North Dakota Department of Transportation

ADDENDUM 1 – JOB 2

TO: All prospective bidders on projects SOIA-7-085(096)192, Job No. 2 scheduled for the May 22, 2014 bid opening.

SRF No. 7594

Revised 5/12/2014	STATE	PROJECT NO.	SECTION NO.	SHEET NO.
	ND	SOIA-7-085(096)192	90	16

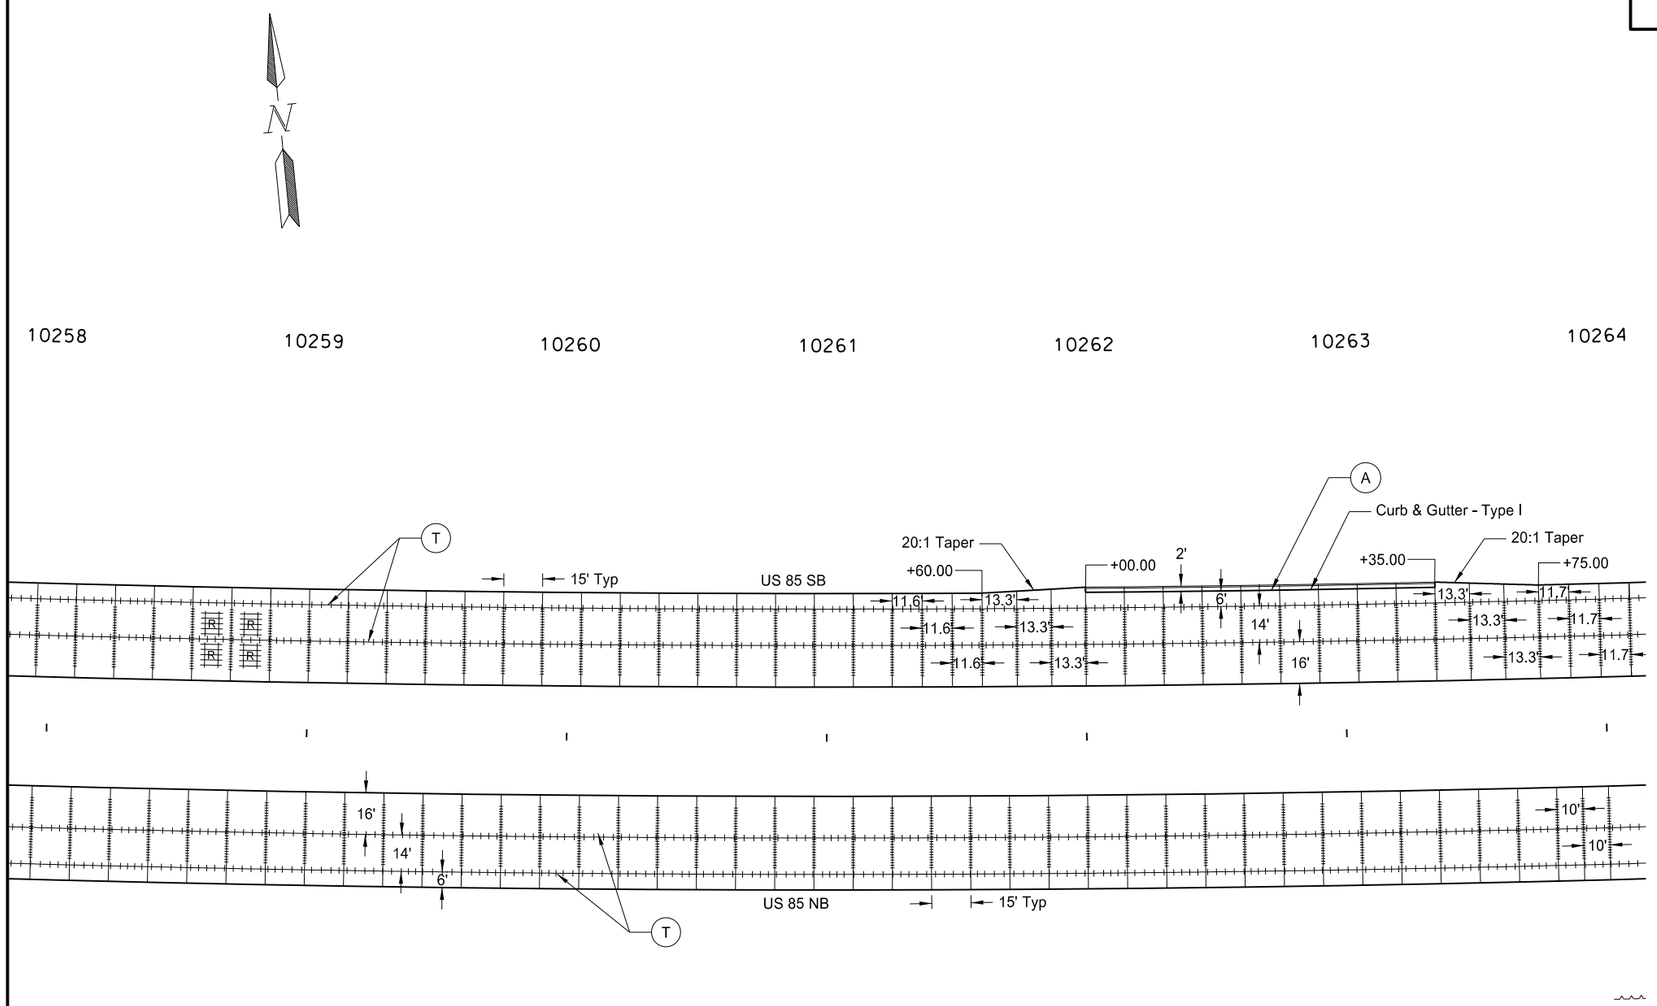
Sheet 90-16:
Revised paving joint layout and quantities due to change in retaining wall.

Revised 5/12/2014	STATE	PROJECT NO.	SECTION NO.	SHEET NO.
	ND	SOIA-7-085(096)192	90	17

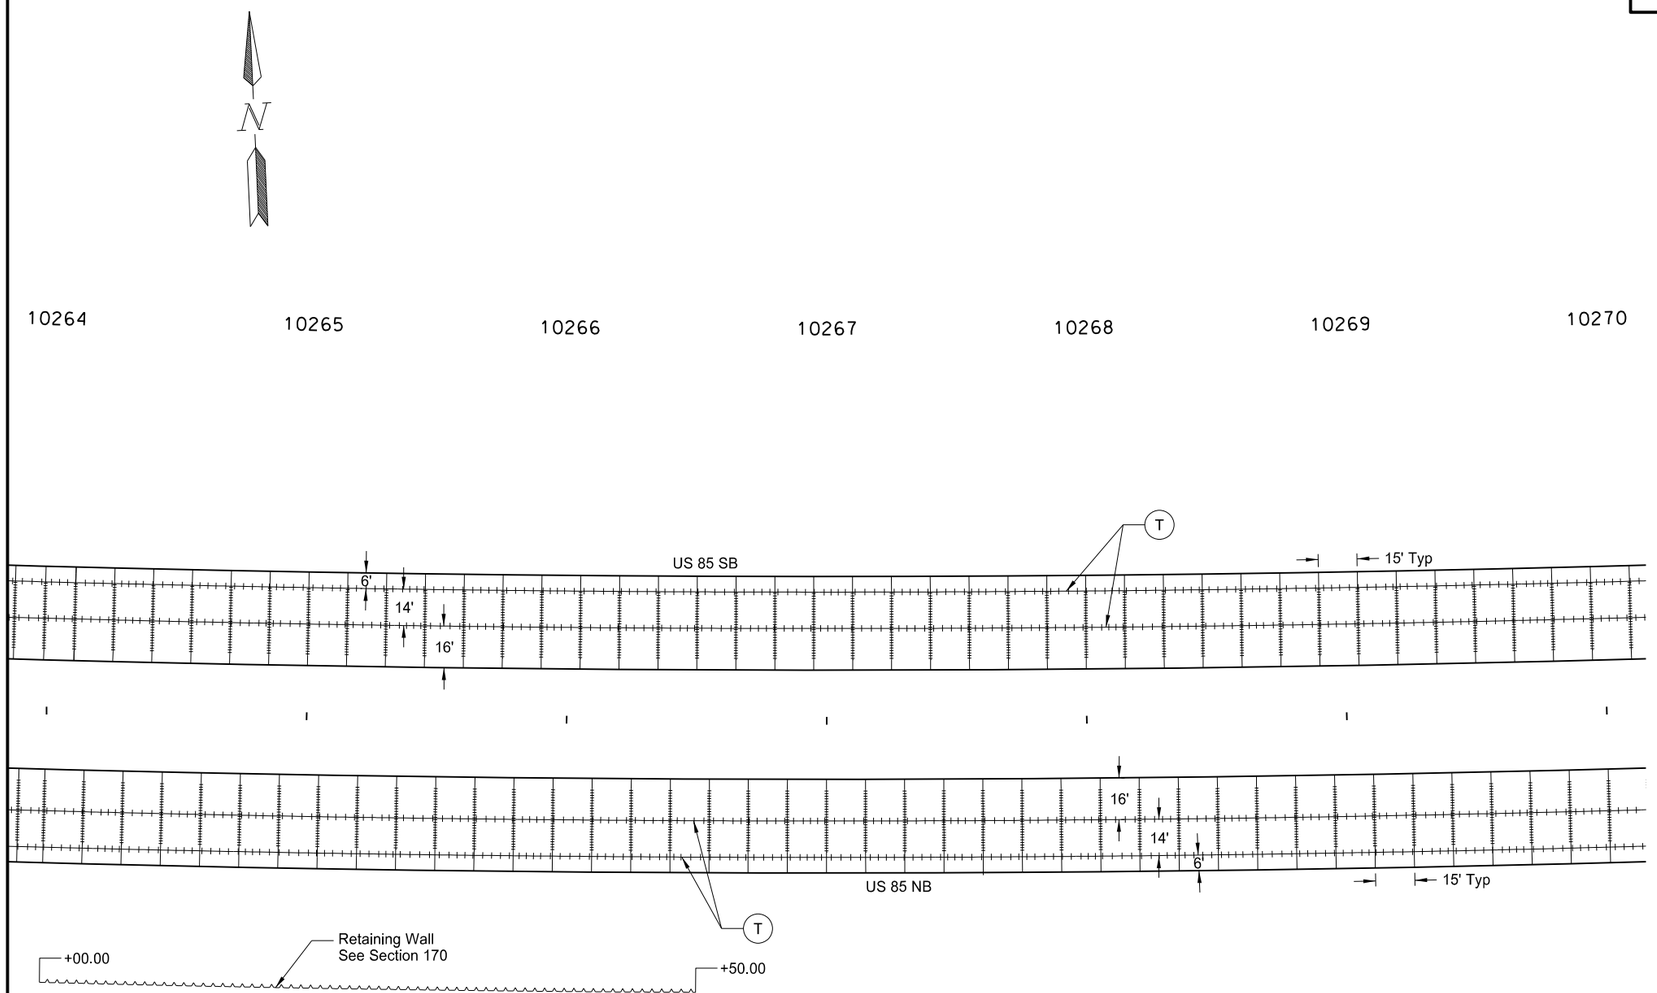
Sheet 90-17:
Revised paving joint layout and quantities due to change in retaining wall.

Revised 5/12/2014	STATE	PROJECT NO.	SECTION NO.	SHEET NO.
	ND	SOIA-7-085(096)192	100	2

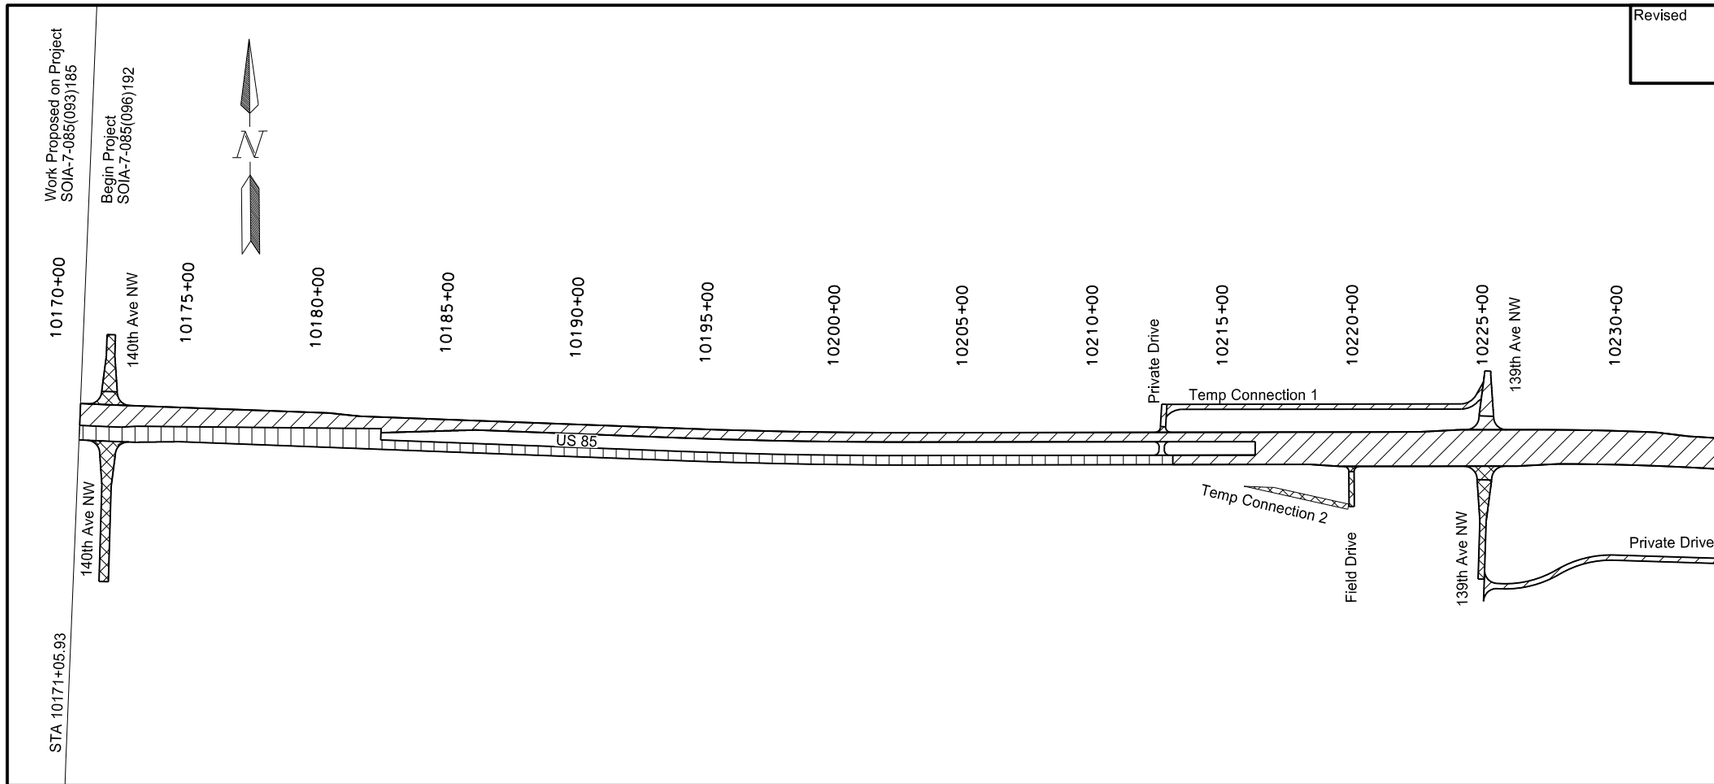
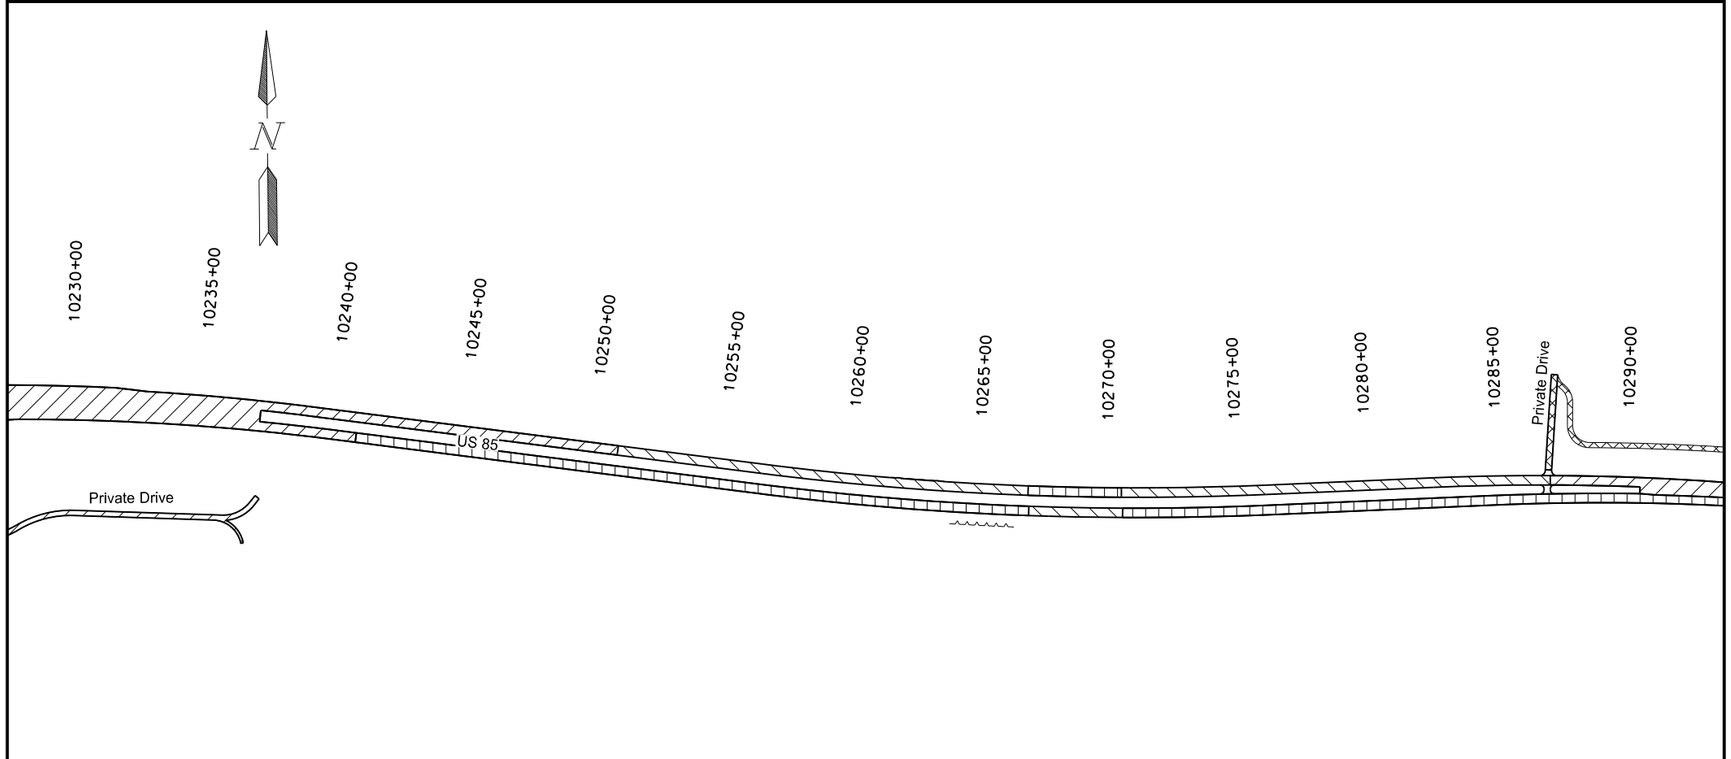
Sheet 100-2:
Revised plan view due to change in retaining wall.

Revised 5/12/2014	STATE	PROJECT NO.	SECTION NO.	SHEET NO.
	ND	SOIA-7-085(096)192	100	11

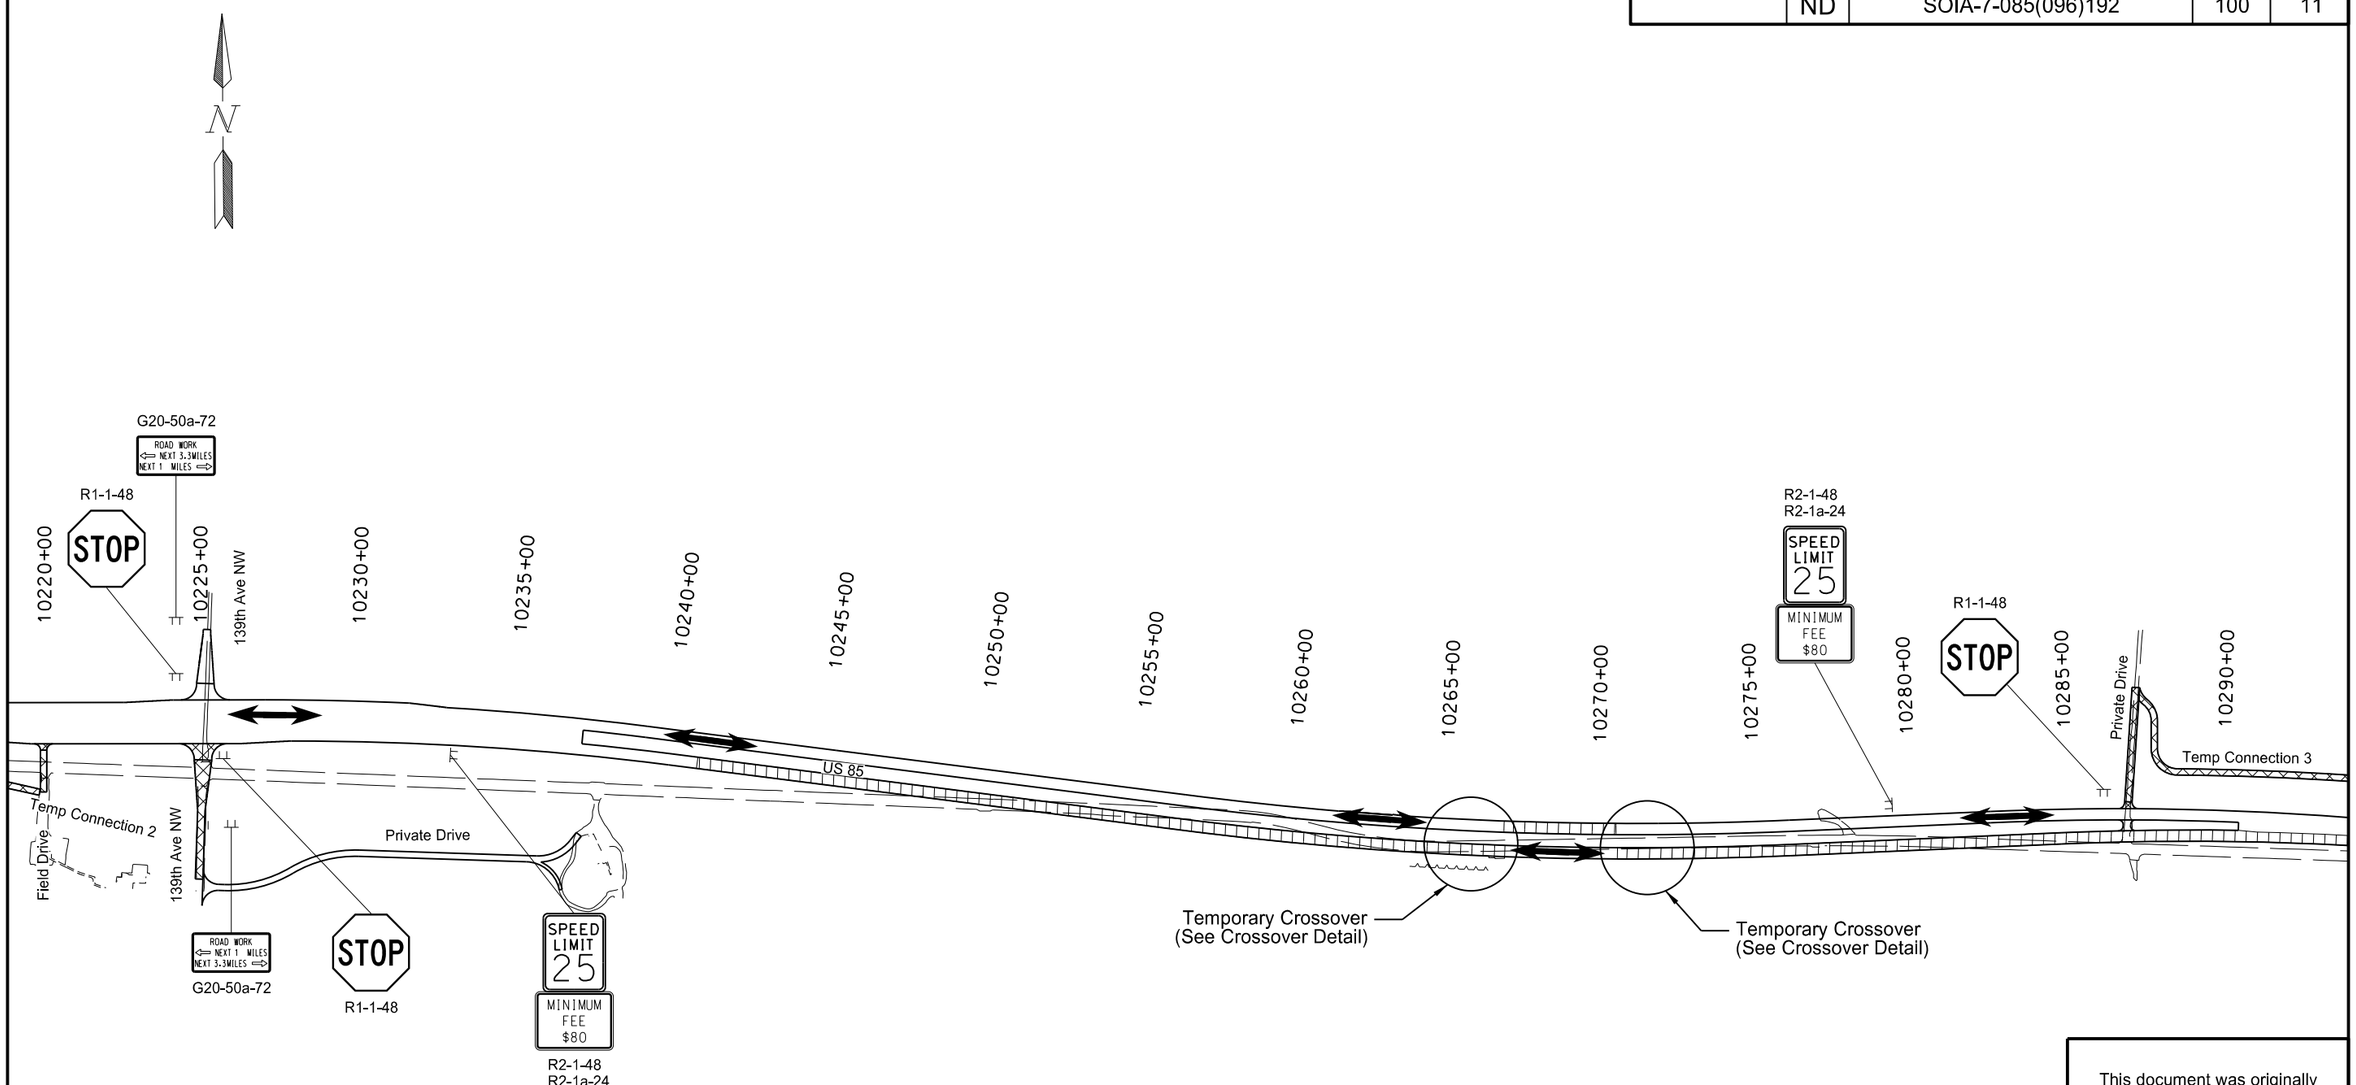
Sheet 100-11:
Revised plan view due to change in retaining wall.

Revised 5/12/2014	STATE	PROJECT NO.	SECTION NO.	SHEET NO.
	ND	SOIA-7-085(096)192	100	15

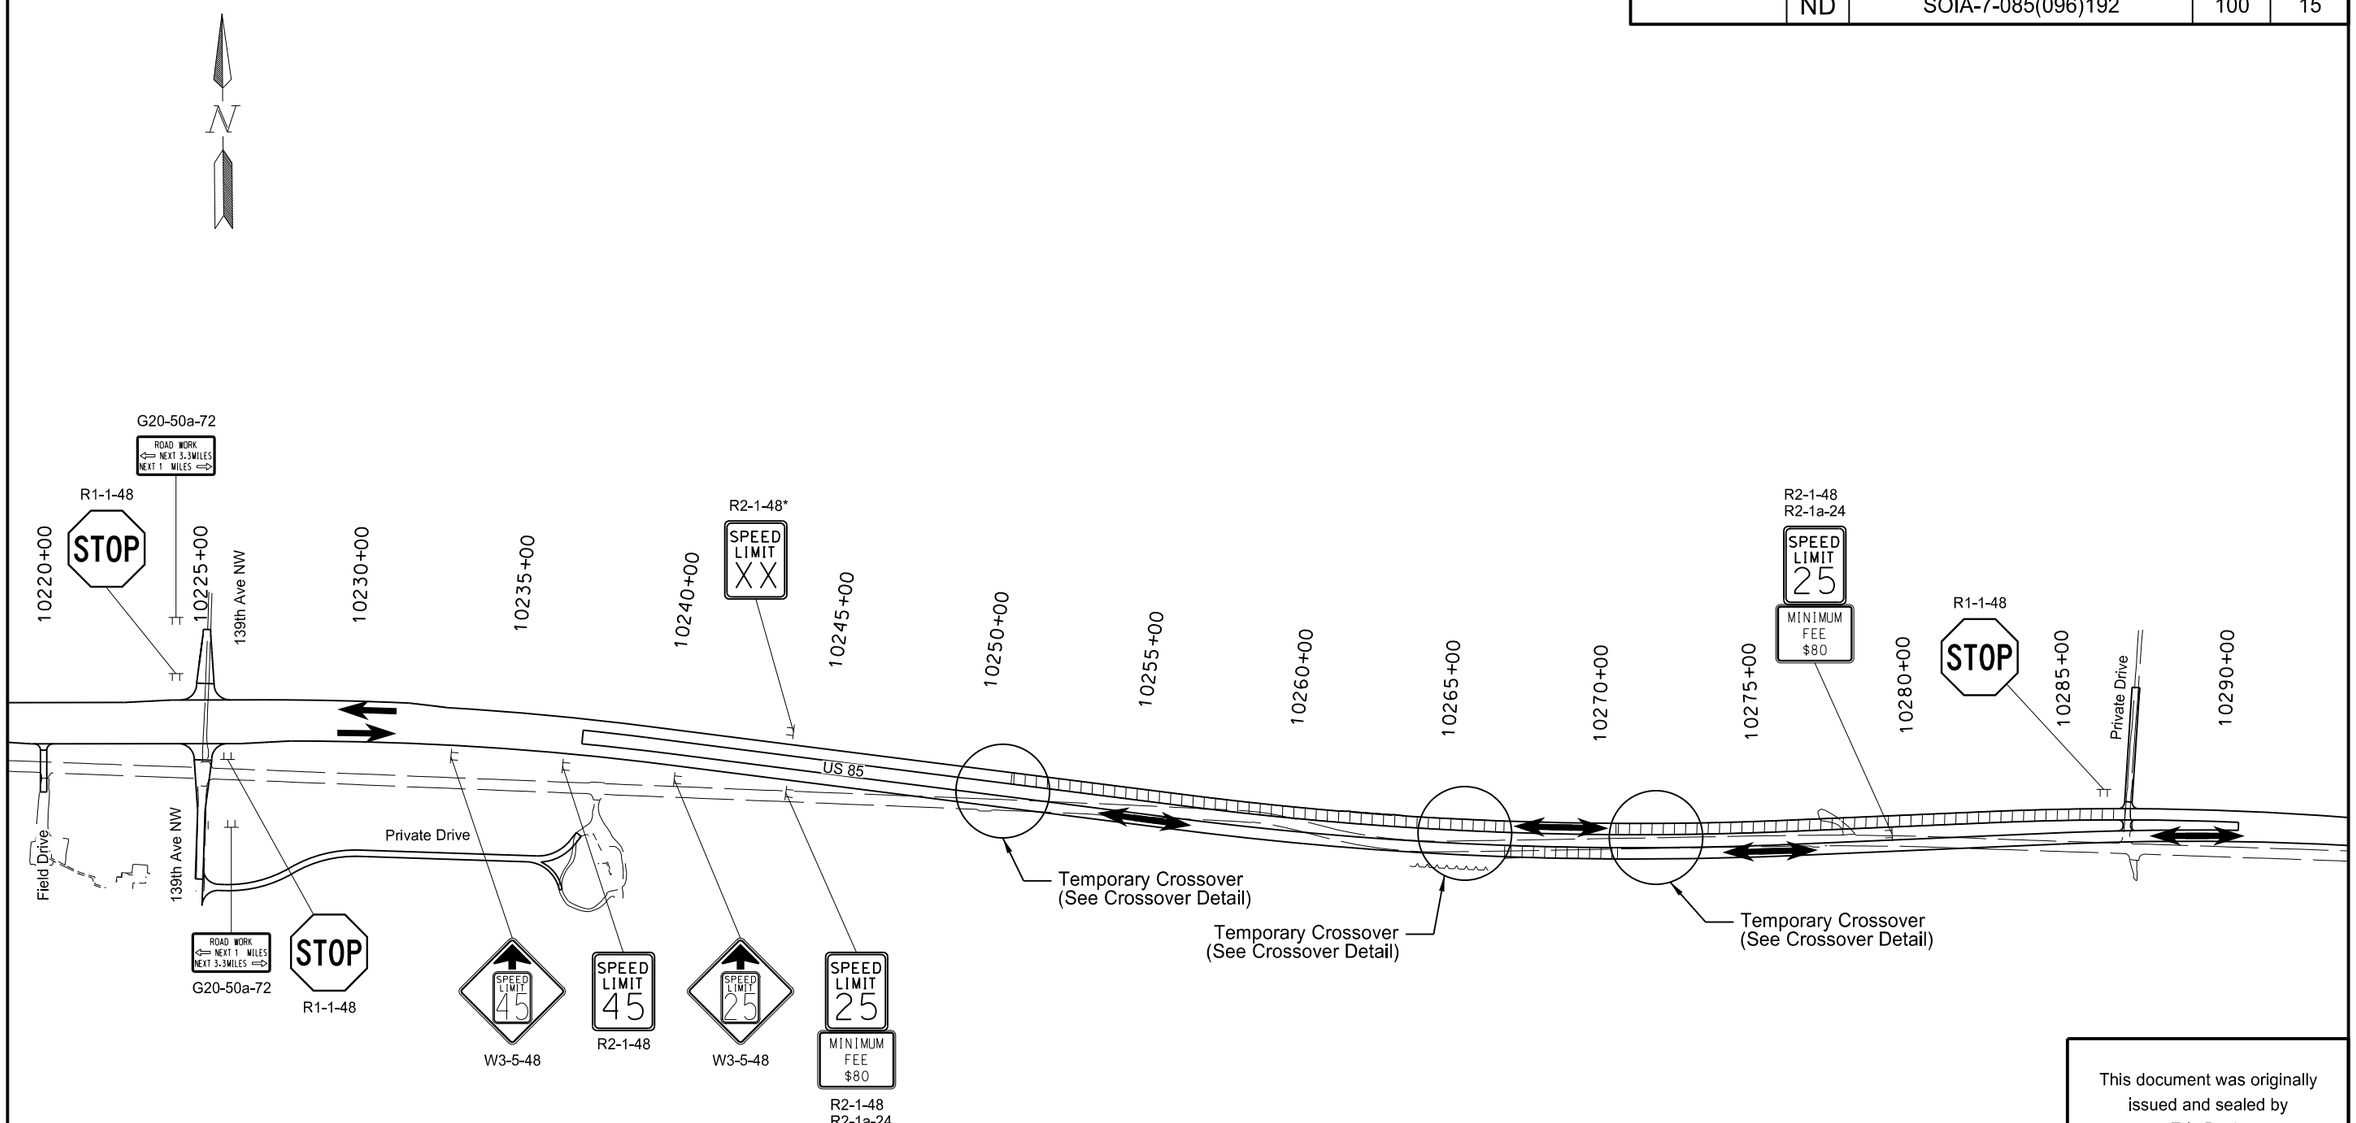
Sheet 100-15:
Revised plan view due to change in retaining wall.
